STAFF MEMORANDUM

RE: Text amendment of the commercial design standards Chapter 19.60.060 for mixed-use building and development requirements

File No: ZT-22-001

CURRENTLY WRITTEN

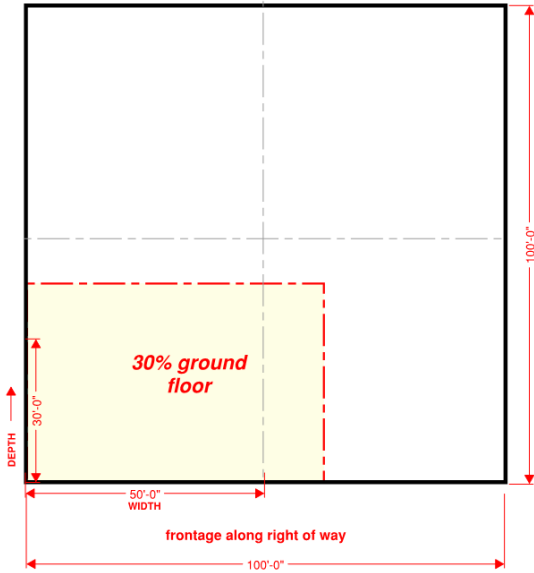
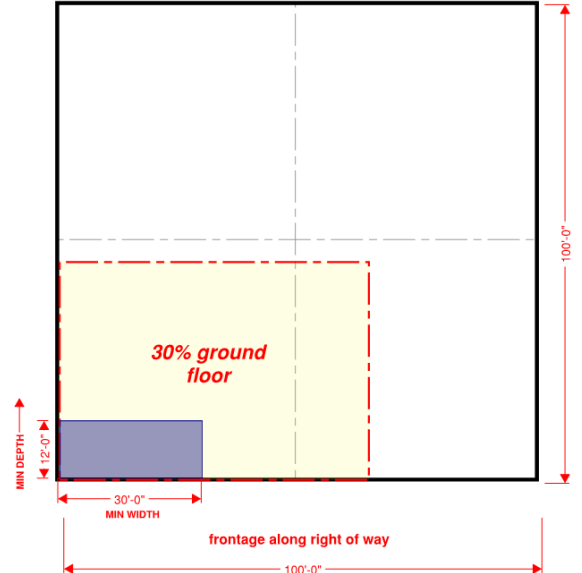
6. Depth of Commercial Space: Depth of commercial space may be measured parallel and along the street frontage or perpendicular to the street frontage.

(1) Depth measured parallel and along the street frontage or perpendicular to the street frontage shall meet all standards and requirements for vertical and unified site plan for mixed use development Chapter 19.60.060 (1-5).

(2) Depth measured perpendicular to the street frontage must have a minimum depth of 12' feet.

Staff is not opposed to the proposed text amendment of the commercial design standards Chapter 19.60.060 for mixed-use building and development requirements. Staff finds that the proposed text amendment essentially provides clarity for how “depth” is measured while securing the main intent of the first floor commercial standards.

While depth may be measured parallel to the street frontage along the right-of-way with a minimum perpendicular depth of 12 feet, requiring that all other standards and requirements shall be met prevents a loophole from providing a first floor commercial space that does not meet the intent of the code.
